Engineering Handbook

SURFACE EQUIPMENT (EHB-8)

MODIFICATION INDEX - CLOUD MEASURING EQUIPMENT

CLOUD HEIGHT MEASUREMENT EQUIPMENT MODIFICATION NO. 21
(For Electronics Technicians)

BACK SIDE OF TRANSMIT LOGIC BOARD

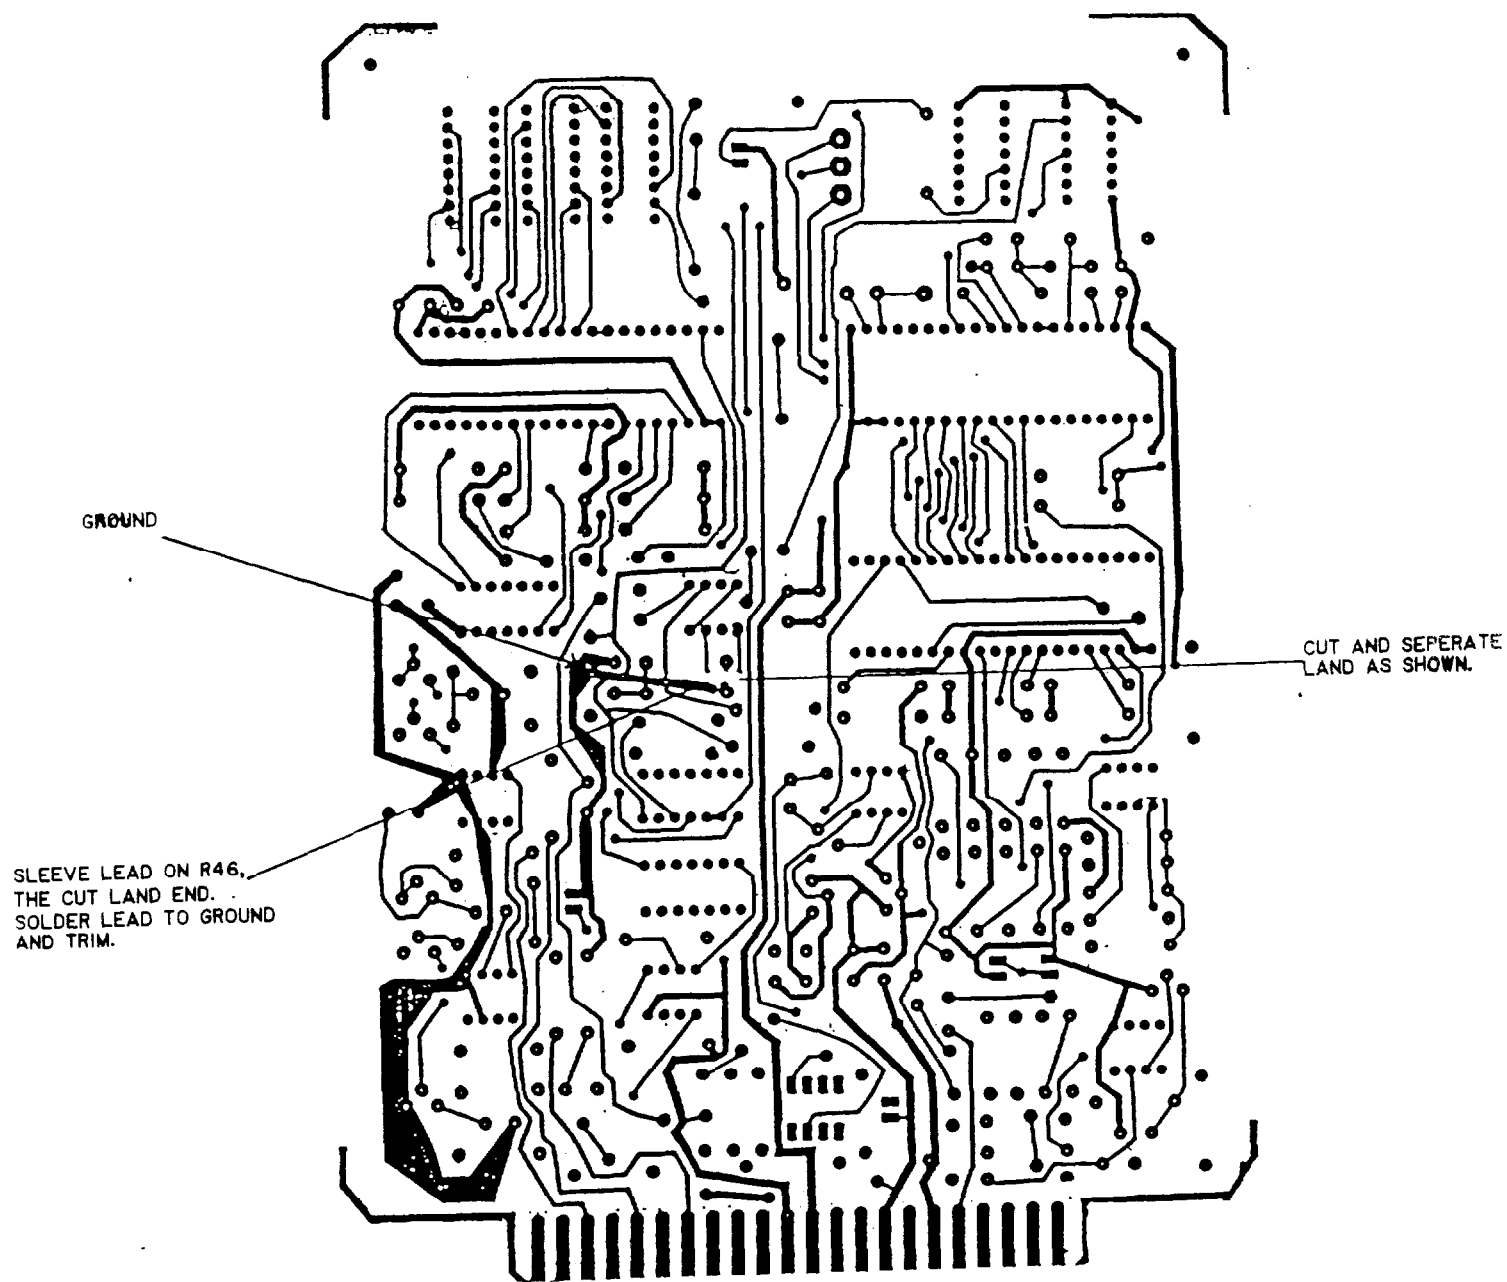
1. Remove the transmitter logic board from the spares kit and unsolder and remove R45, C18, and CR12. See Figure 1.
2. Position transmit logic board with component side up on work bench and locate an unidentified capacitor, located between R45 and CR12. Turn board over and locate the leads to this capacitor. Between these leads will be found a land that will have to be cut and separated. See Figure 2. Cut and separate the land.

NOTE: 1. FILTER TO BE MOUNTED WITH DARK SIDE
TOWARDS BOARD AND BRIGHT SIDE VISIBLE
2. DO NOT TOUCH WITH BARE HANDS
EXCEPT AT EDGES!

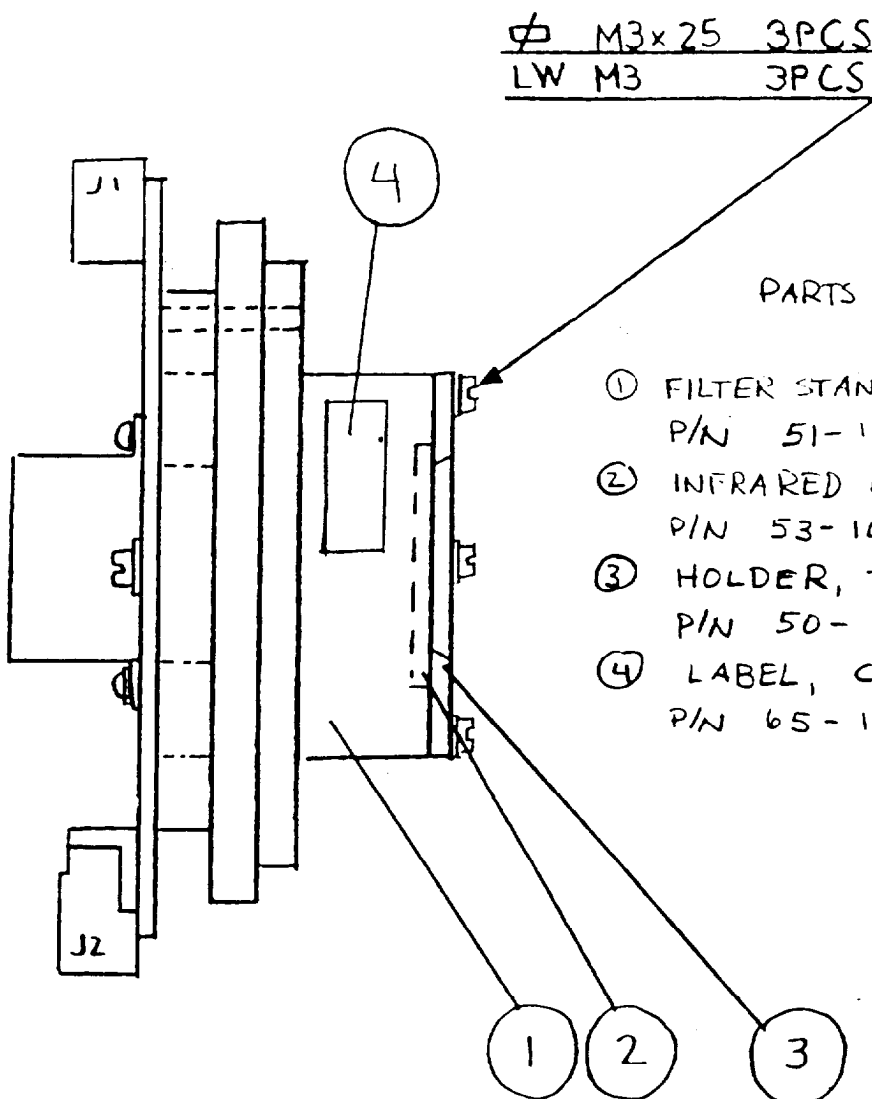
1. Remove the three screws on the holding ring.
2. Remove the holding ring and the old filter.
3. Set the standoff block, new filter and new holding ring up on the receiver block as shown in DWG 4572. Do not touch the filter on its face. The filter is mounted with the dark side in.
4. Use the long screws to tighten down the assembly.
5. Attach the "CTR13B" sticker to the standoff block.

FIGURE 1
MMTS INTERIM
LIGHTNING MODIFICATION

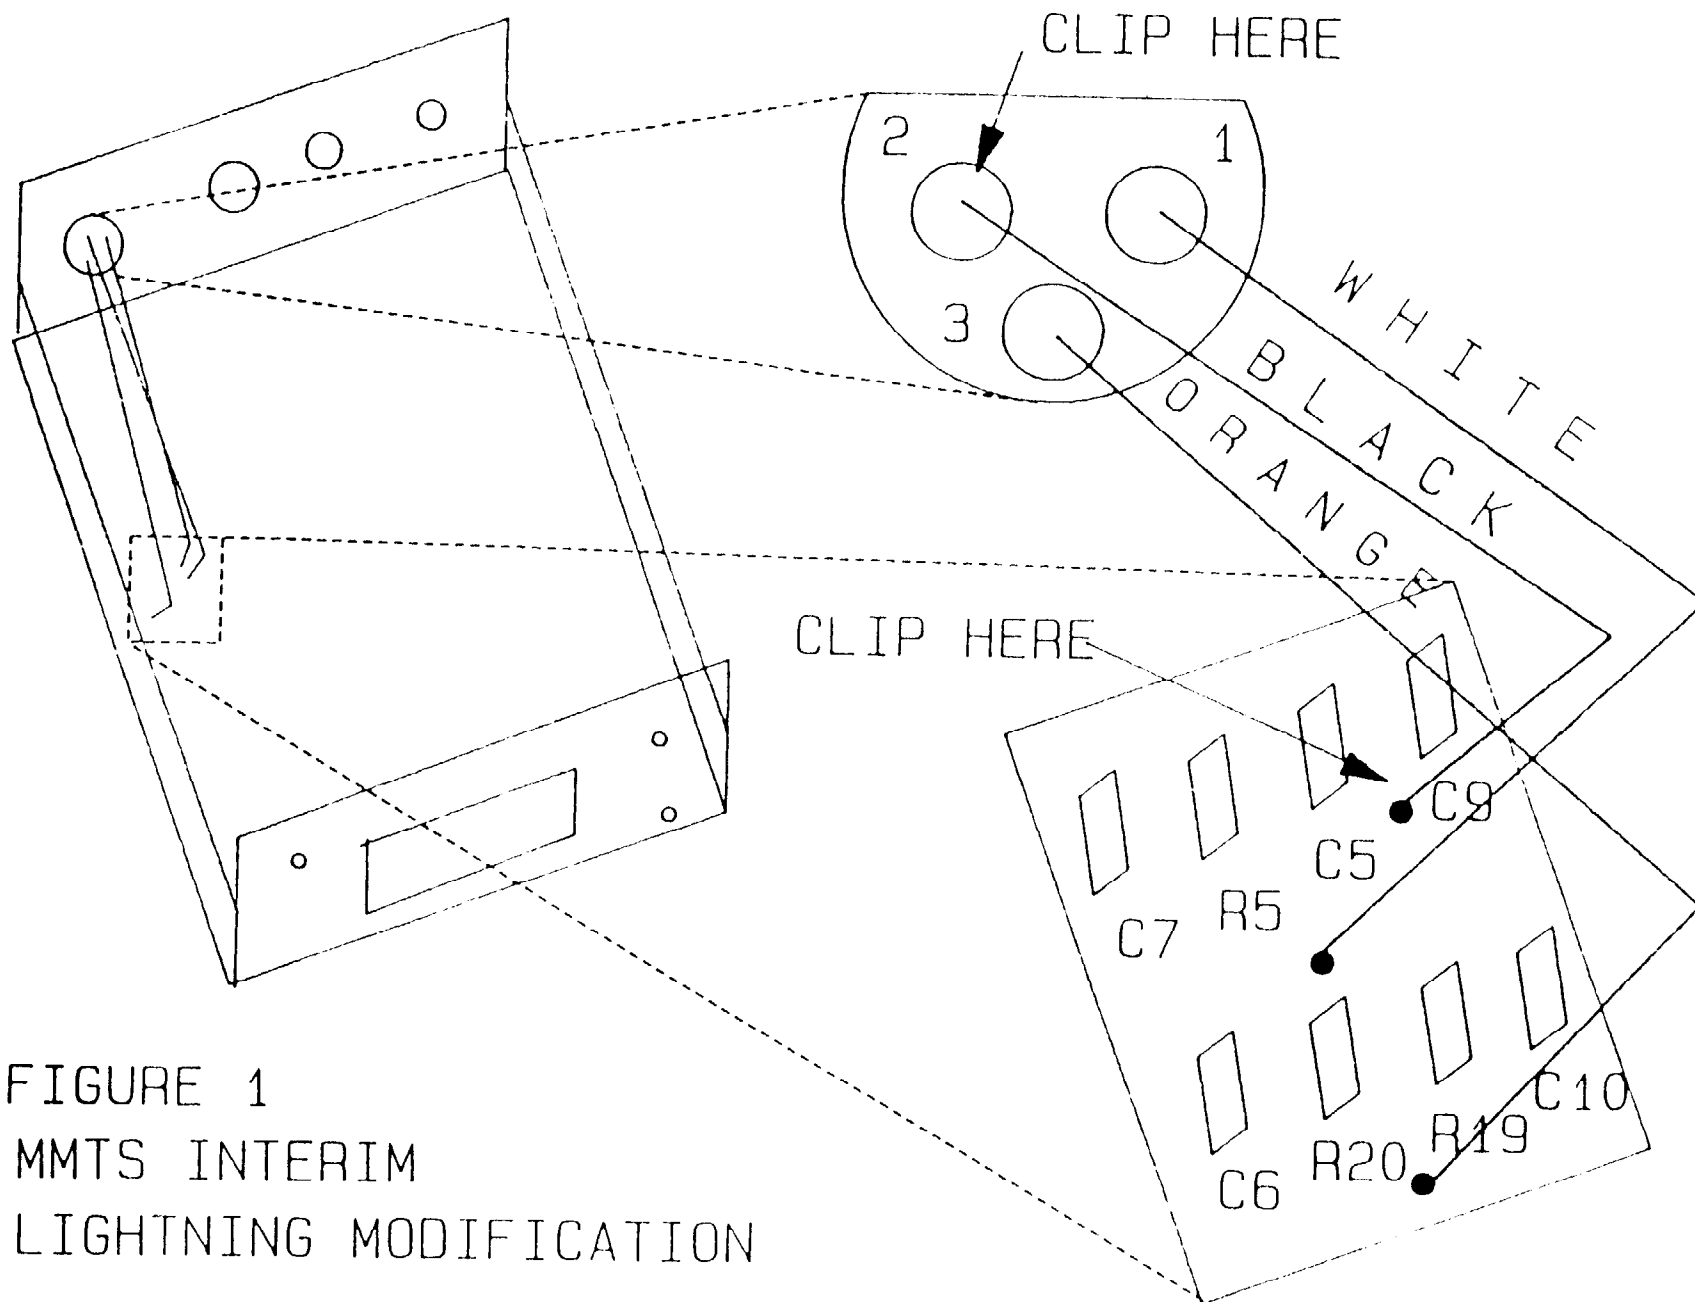
3. Remove the two Phillips head screws which hold the display unit case together. Place the display unit upright and remove the top half of the case.
4. Reference figure 1. With the front of the unit facing you, locate three wires that connect the printed circuit board to the sensor cable connector. Locate the wire that connects pin 2 of the connector to the area of the printed circuit board between the capacitors C5 and C9. This wire is usually black in color.

FIGURE 1
FUNNEL CAP

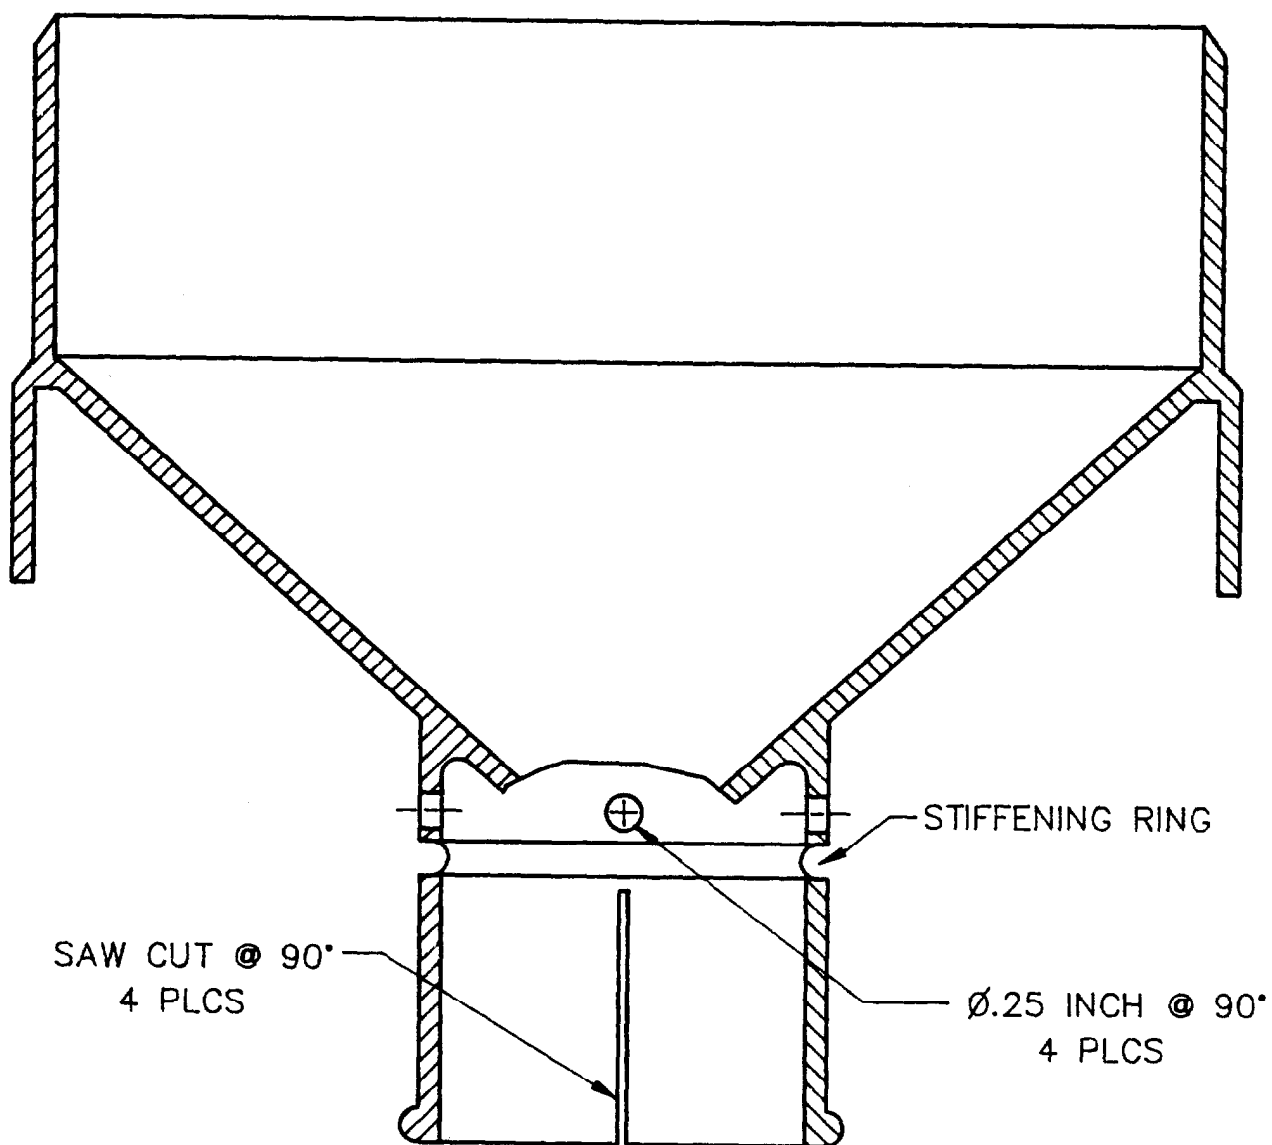
1. Remove the copper funnel cap from the 8-inch nonrecording rain gauge.
2. Divide the opening where the measuring tube goes into the funnel cap into four equal sections. Drill four 1/4-inch holes above the stiffening ring as shown in figure 1. This allows the water to overflow from the measuring tube into the can.
3. Cut the measuring tube opening of the funnel cap in four places using a hacksaw (refer to figure 1). The cuts should be straight and stop just below the stiffening ring on the funnel cap. Do not cut through the stiffening ring.
4. It may be necessary to pull the sections made on the funnel cap slightly open to accommodate the plastic measuring tube. The plastic measuring tube should fit flush against the stiffening ring when installed on the funnel cap.
5. This concludes this modification. Restore gauge for operational use.
